**NEW YORK STATE THRUWAY AUTHORITY  
DEPARTMENT OF ENGINEERING**

**AMENDMENT NO. 1  
TO**

**CONTRACT TAS 24-1  
D214944  
PAVEMENT REHABILITATION AND MISCELLANEOUS  
WORK FROM MILEPOST 347.1 TO 351.4 EB/WB  
IN THE SYRACUSE AND BUFFALO DIVISIONS  
OF THE NEW YORK STATE THRUWAY  
IN ONTARIO COUNTY**

CONTRACT NUMBER:  
TAS 24-1  
DATE:  
06/21/2024  
DRAWING NUMBER:  
WZD-01

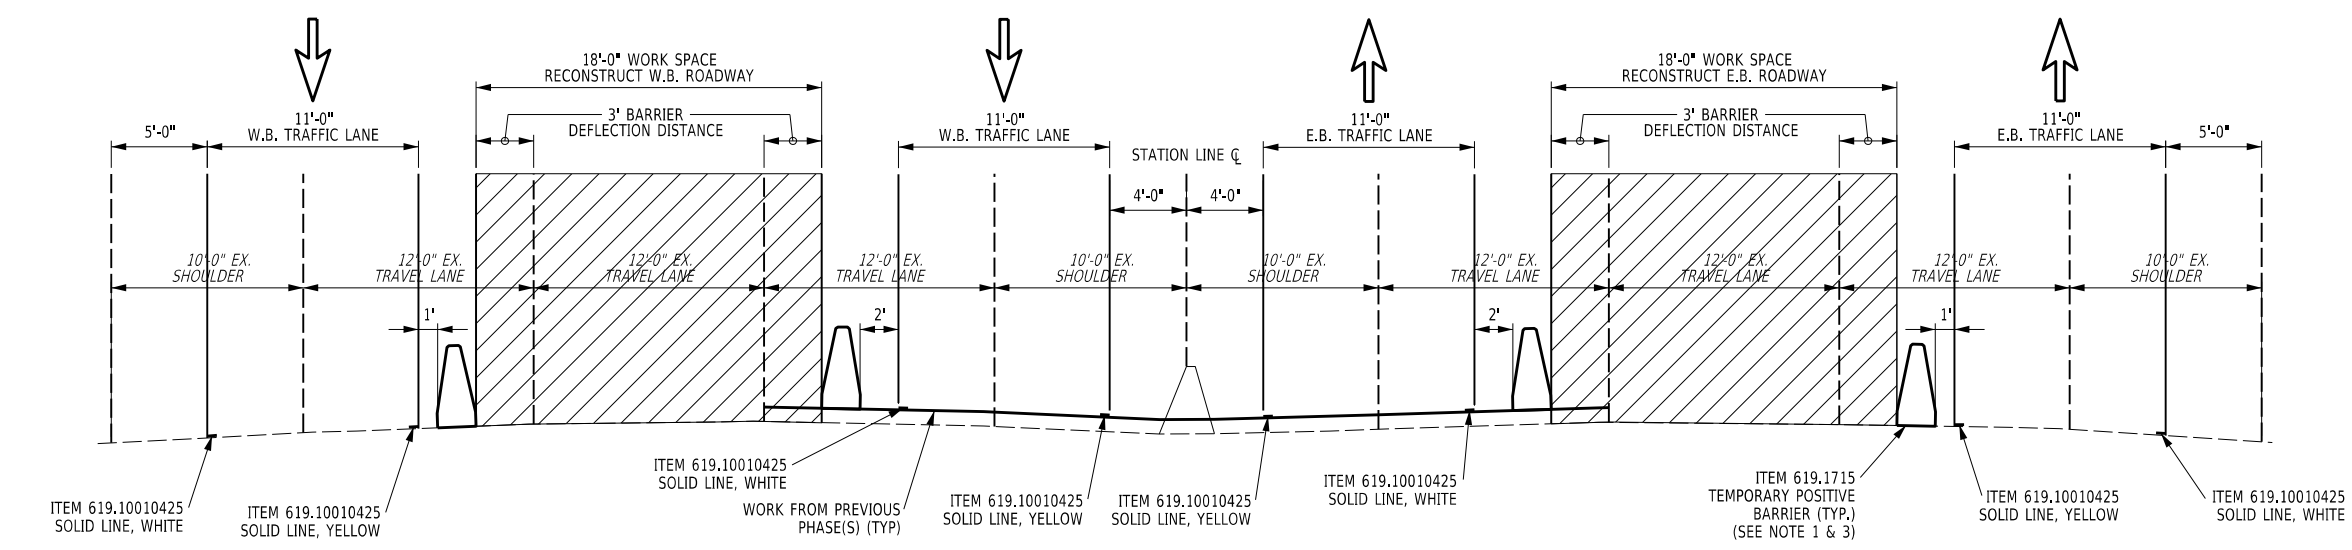
5. **DELETE** Drawing WZD-01, Sheet 27 of 372, and **SUBSTITUTE** with the attached Drawing WZD-01, Sheet 27A1 of 372. Notes have been added and removed to clarify time restrictions, towing services and striping removal items.
6. **DELETE** Drawing WZD-02, Sheet 28 of 372, and **SUBSTITUTE** with the attached Drawing WZD-02, Sheet 28A1 of 372. Notes have been added and removed to clarify time restrictions, towing services and striping removal items.
7. **DELETE** Drawing OSS-1, Sheet 363 of 372, and **SUBSTITUTE** with the attached Drawing OSS-1, Sheet 363-A1 of 372. An erroneous data line entry has been removed from immediately below the Cantilever Structure Table.

- NOTES:
- TEMPORARY POSITIVE BARRIER SHALL BE CATEGORY 5 FOR UNPINNED BARRIER.
  - ALL EXISTING PAVEMENT MARKINGS WILL BE REMOVED PRIOR TO THE ADDITION OF THE INTERIM PAVEMENT MARKING.

- USE LINEAR DELINEATION SYSTEM (TRAFFIC SIDE), ITEM 619.17060025, ON ALL TANGENT RUNS.
  - DURING PHASE II, CONTRACTOR SHALL SUPPLY BOTH A LIGHT AND HEAVY TOWING SERVICE, ITEM 619.80010025 AND ITEM 619.80020025, RESPECTIVELY. TOWING SERVICES SHALL BE FOR MONDAY THROUGH FRIDAY DURING THE HOURS OF 6AM TO 10AM AND 2PM TO 6PM.

- CONTRACTOR TO REMOVE CONFLICTING PAVEMENT MARKINGS FOR ALL WZTC PHASES IN LIVE TRAFFIC LANES. REMOVALS ARE TO BE DONE USING ITEM 619.08010125 - REMOVE PAVEMENT MARKING STRIPES, TRAFFIC PAINT - FOR AREAS WHERE PAVEMENT WILL BE OVERLAIN WITH NEW PAVEMENT OR RECONSTRUCTED. REMOVALS ARE TO BE DONE USING ITEM 619.08030025 - COVER EXISTING PAVEMENT MARKING STRIPES (REMOVABLE TAPE) - FOR AREAS WHERE EXISTING PAVEMENT WILL REMAIN AFTER TEMPORARY TRAVEL PATTERNS ARE REMOVED.
